CITY OF ALBUQUERQUE

October 10, 2007

Re: North 2nd St. Business Center Grading and Drainage Plan
Engineer's Stamp dated 10-4-07 (F15/D052)

Cross Section for 24ft ff

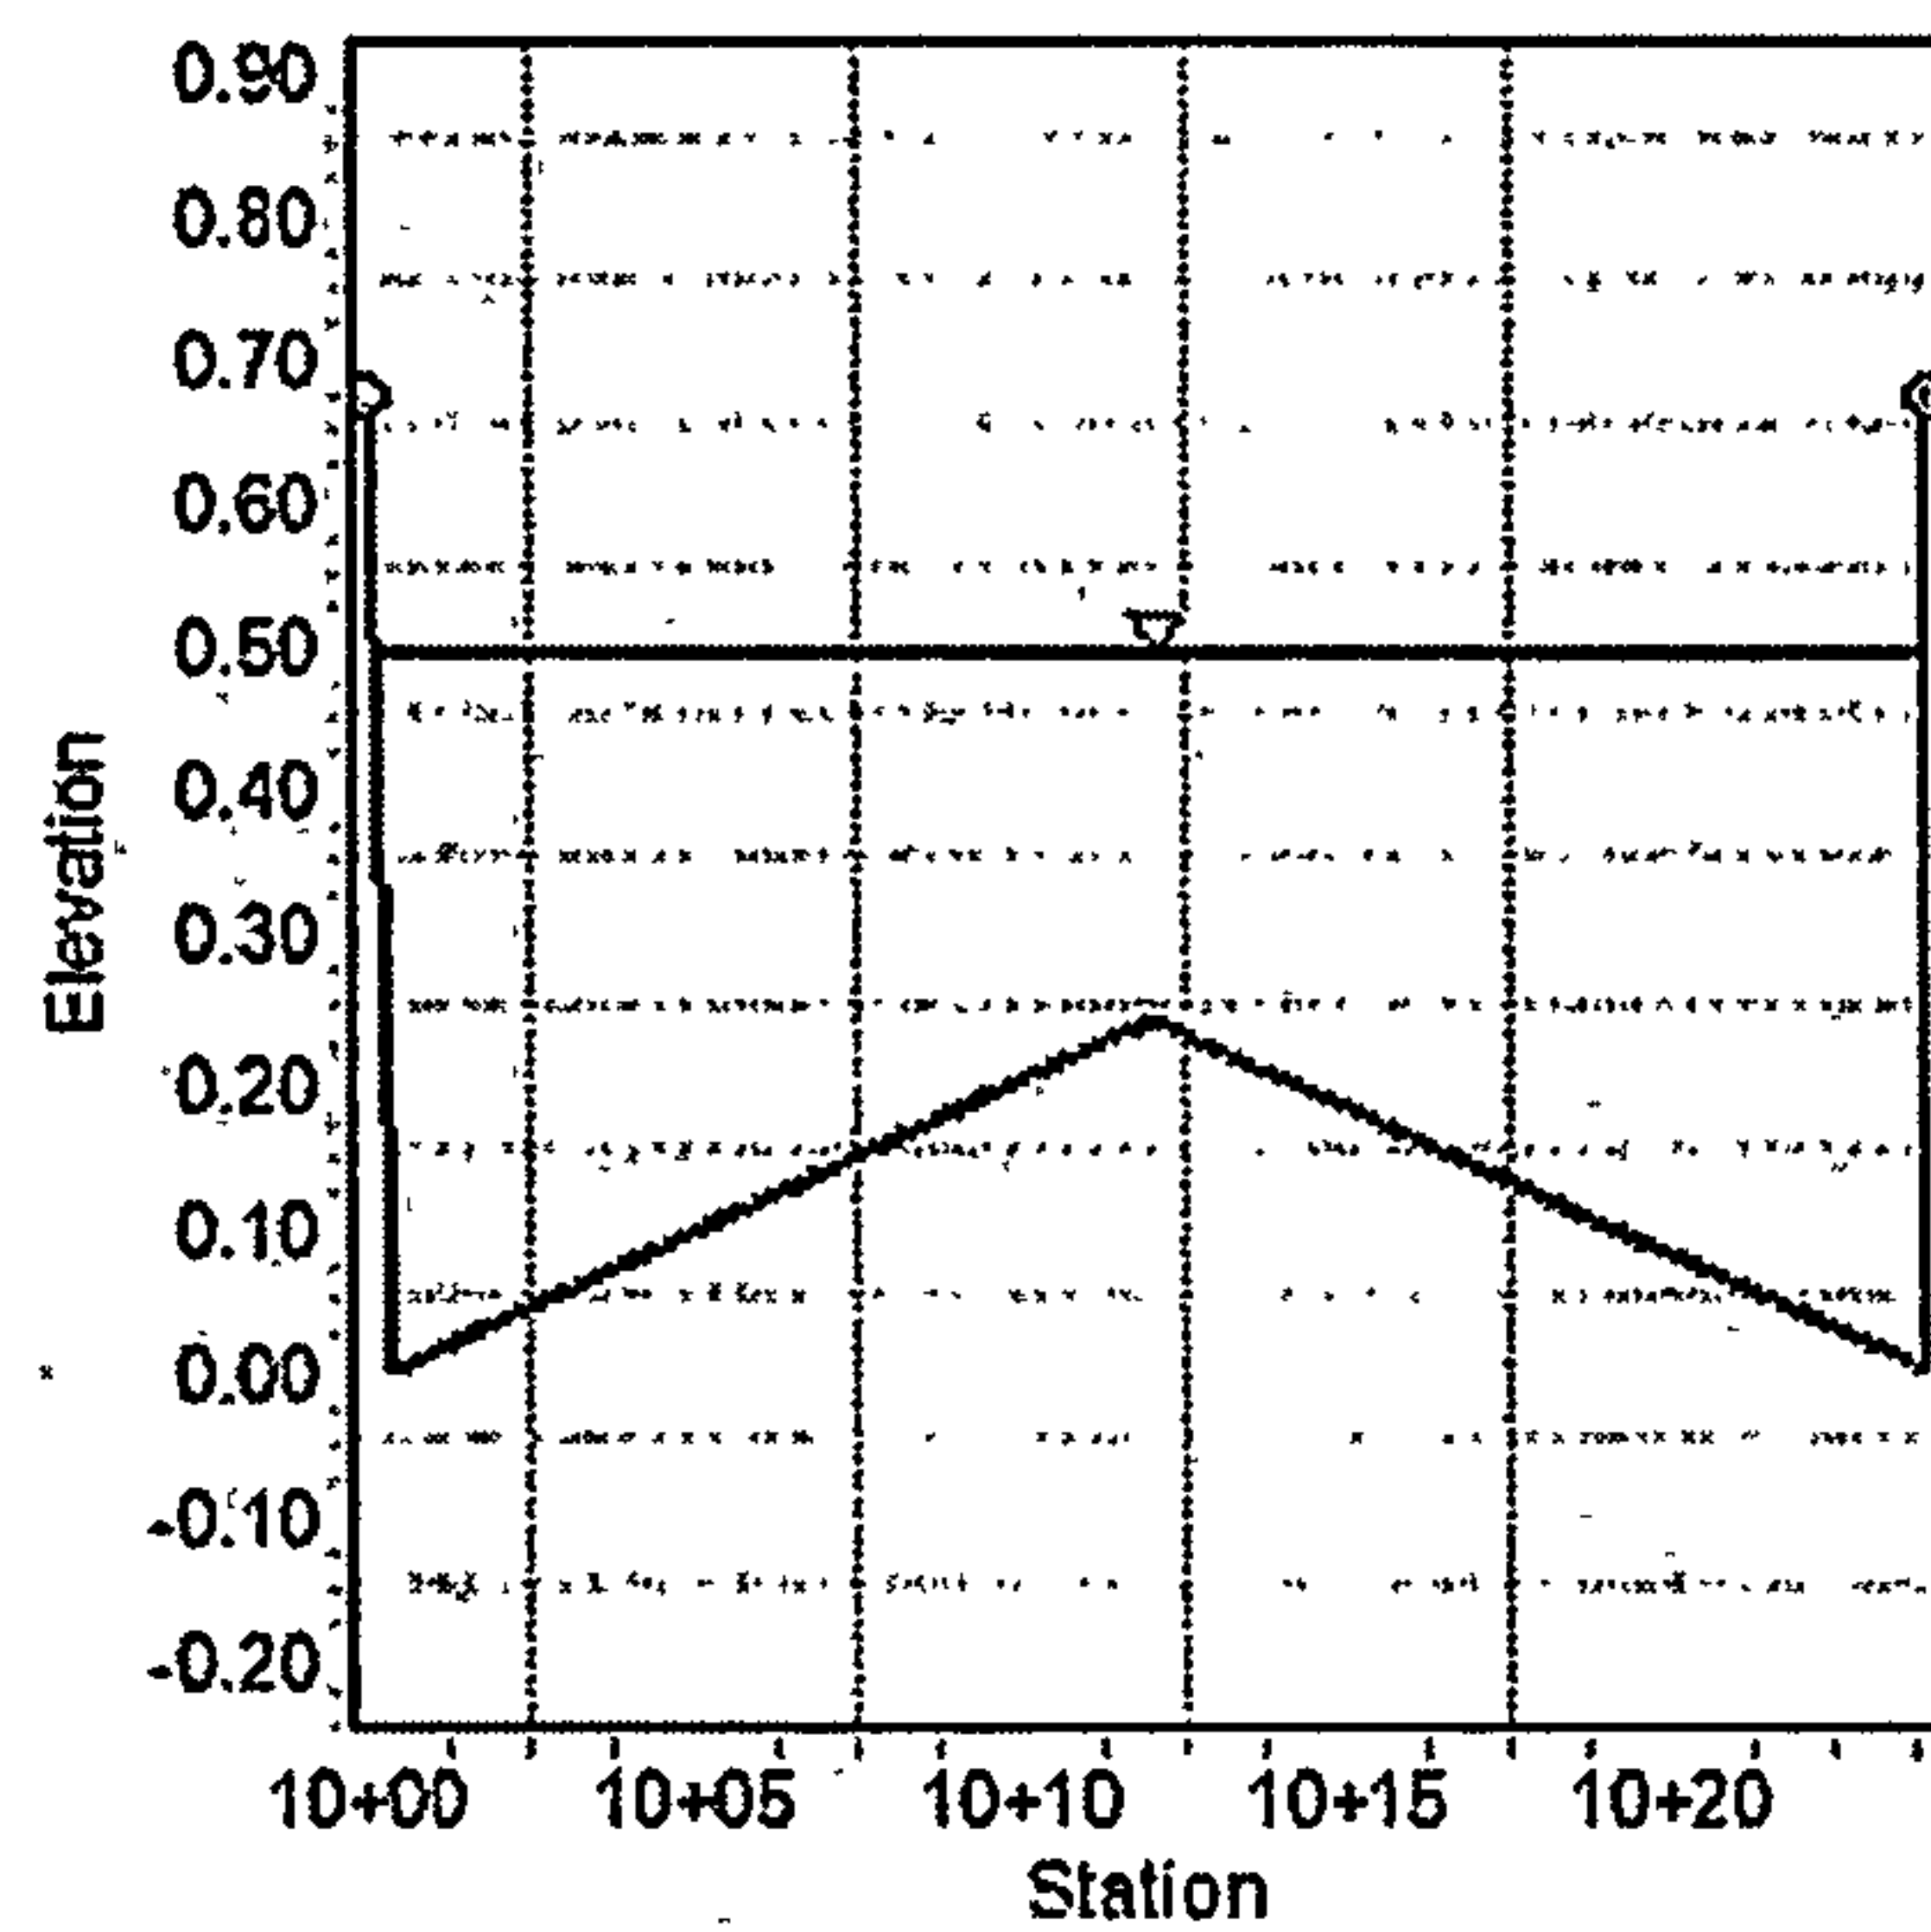
- As mentioned at DRC on Monday, October 8th, the grade of the private road needs to be increased to 0.5%. This will affect grades shown on this plan.

- The capacity of the private road was calculated using an incorrect longitudinal slope of 6.25%.
